RE: RESPONSE TO INFORMATION REQUEST FOR TOWN PLANNING APPLICATION FOR:-

- A) MATERIAL CHANGE OF USE – IMPACT ASSESSMENT FOR UNDEFINED USE (WORKERS' ACCOMMODATION), TOURIST PARK AND CARETAKER'S ACCOMMODATION AND ASSOCIATED AND ANCILLARY FACILITIES IN TWO (2) STAGES; AND**
- B) OPERATIONAL WORK – IMPACT ASSESSMENT FOR ADVERTISING DEVICE (FREESTANDING SIGN)**

**ON LAND DESCRIBED AS PART OF LOT 2 ON RP745166 AND LOCATED AT LOT 2 CAPTAIN COOK HIGHWAY, PORT DOUGLAS
COUNCIL REF: CA 2025_5732
SARA REF: 2503-45404 SRA**

In this regard, we refer to Council's Information Request dated 3 April 2025 and Council's email dated 26 November 2025 providing an extension to the Applicant Response Period to 19 December 2025.

SCALE (Scale as shown)
DRAWING
23070-C01
REF
B

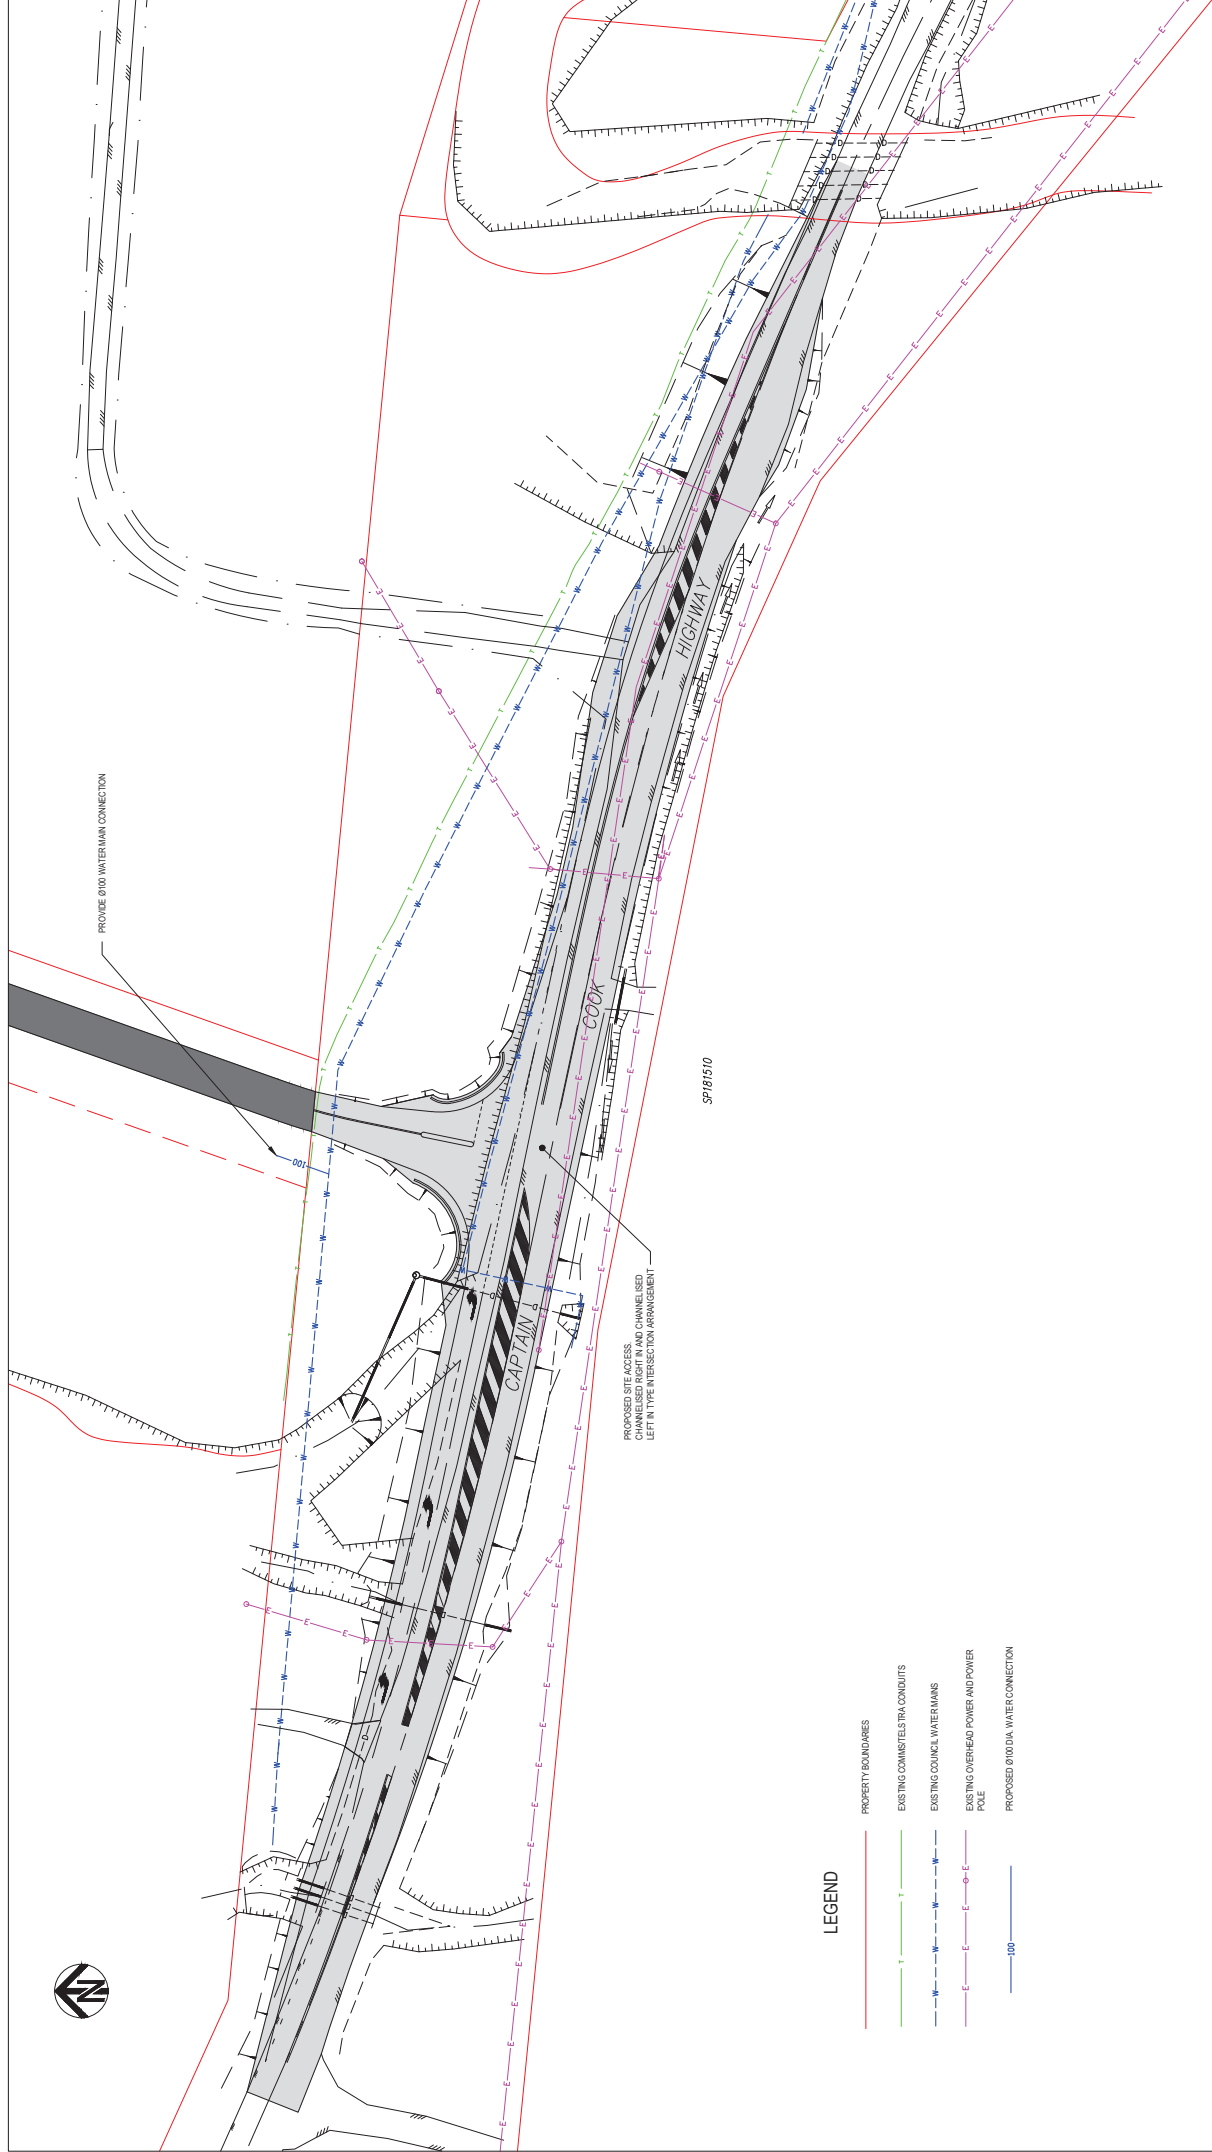
The proposed intersection upgrade shown on Drawing C01, shows that a 140m length of the 450 DICL trunk main will be located beneath the road pavement (figure below). This is undesirable for maintenance and repair of the watermain. Relocation of the main to be outside of the road pavement or a protection measure (e.g. concrete encasement) may be warranted depending on the alignment and cover depth of the pipe relative to the finished surface.

The driveway access leg of the intersection crosses a 10m length of the 300 AC trunk main (figure below). Replacement of the main in DICL or protection measures (e.g. concrete encasement) may be warranted depending on the alignment and cover depth of the pipe relative to the finished surface.

“Once the intersection design is finalised with Transport and Main Roads the final location of the entrance access and road widening will be known. At that stage we will arrange for the exact location of the 300 and 450 water mains. Once the depth and cover have been determined any protective works, such as concrete encasing or watermain class upgrading, will be addressed at OWA stage.”

Figure 3-1 Existing Case (left) and developed case (right) topography

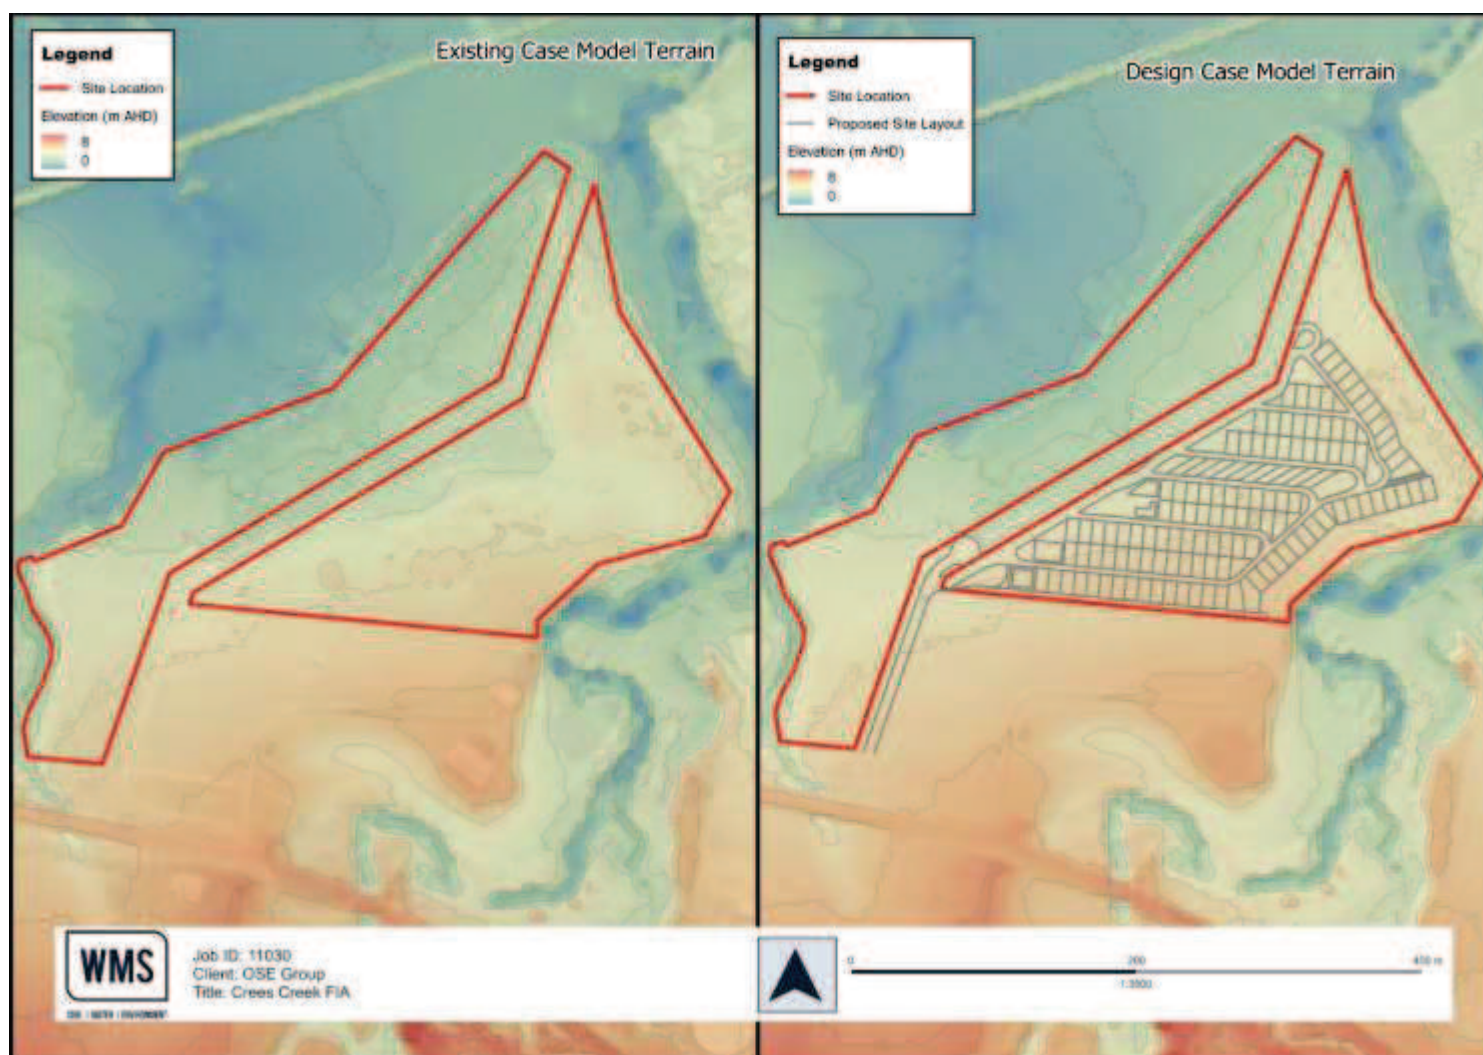
1. Please provide a cut and fill plan for the development. The plans should include pre-development conditions (pre 2022 fill) and required post development fill necessary to achieve immunity for a minimum of 1% AEP event.”

2. Please provide a copy of the flood study and flood modelling for the site. The Study must include modelling to confirm, hydraulic implications and confirm any drainage design necessary to mitigate hydraulic impact of the development. The flood study is to include at least the following matters:

*“A draft flood study of Crees Creek was completed by WSM Engineers (Refer **Appendix 2**). It clearly shows the impact of flooding during the 1% AEP event on the subject land. As a result, the concept cut and fill plan was produced, however, this is subject to review at final design or OWA stage. The final flood study will be completed at OWA stage once the cut and fill plan has been modelled to determine if the final fill levels have caused any afflux in the surrounding area and what may be needed to reduce the effect of any afflux. Fill levels can, if required, be adjusted at OWA stage.”*

A revised design case event will need to be simulated with additional fill added on the site to ensure adequate freeboard to the design case 1% AEP flood level.

INDICATIVE ALIGNMENT FOR
PEDESTRIAN AND CYCLE PATH

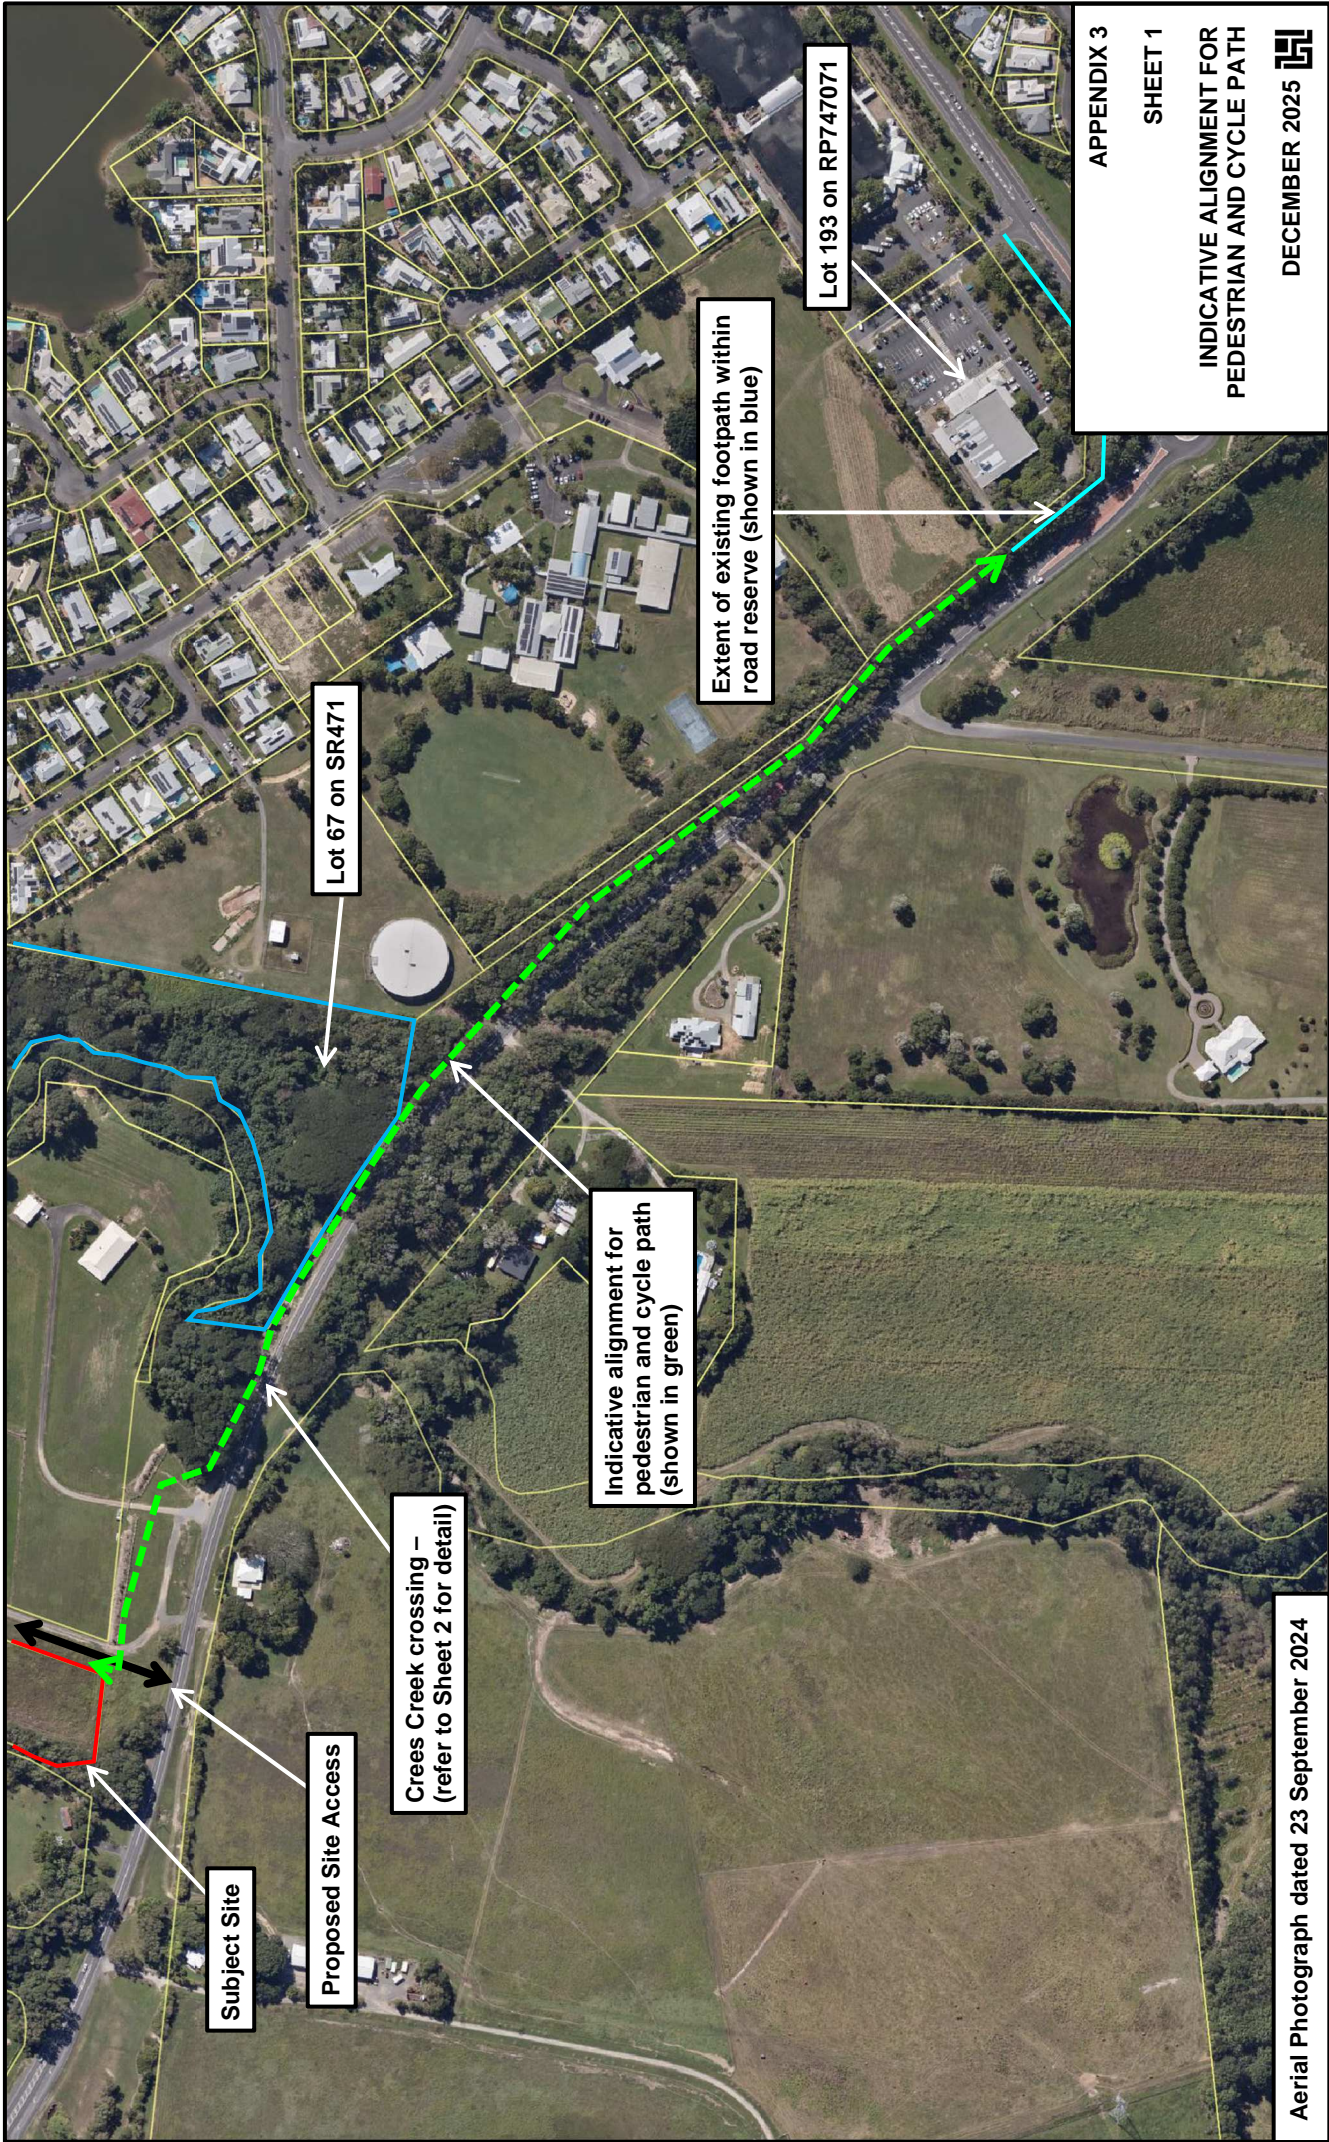
It is important that appropriate and safe pedestrian and bicycle connectivity accompany the development. In this instance, pedestrian and bicycle access needs to be provided to the intersection of the Captain Cook Highway and Port Douglas Road, where the local IGA Shopping complex is located. Without appropriate and safe pedestrian and bicycle connectivity the development is considered inconsistent with the Strategic Framework and the Planning Scheme Codes. The lack of suitable and safe pedestrian / bicycle connectivity is also considered to compromise the safety and functionality of the adjacent State-controlled Road.

8. Please clarify whether these traffic demands rely on the provision of a bicycle / pedestrian network connection being provided.

*"The **attached** Drawings (Refer **Appendix 3**) shows the intended layout of the path to serve as the required pedestrian/cycle pathway. The plan shows two options, and we advise that option B is the preferred location.*
